TECHNICAL BULLETIN

[Issue No.] GOT-A-0136

[Title] Changes to the Rating Plate

[Relevant Models] GOT2000 Series (GT2107-WTBD and GT2107-WTSD)

Before	After

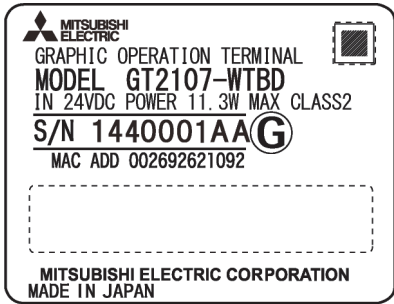
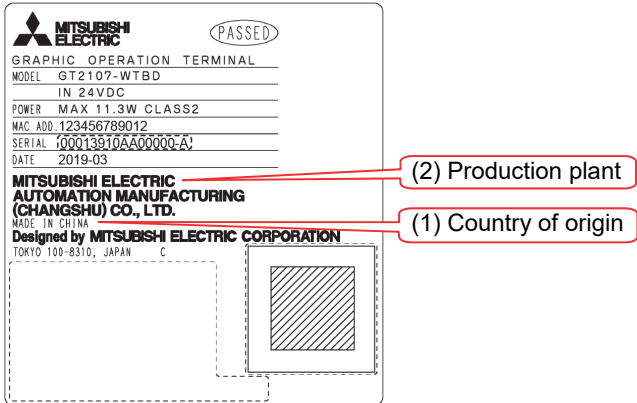
- (1) The country of origin has changed from Japan to China.
- (2) The production plant has changed.
- (3) Labeling has changed to silk-screen printing on the GOT.

Labeling	Silk-screen printing
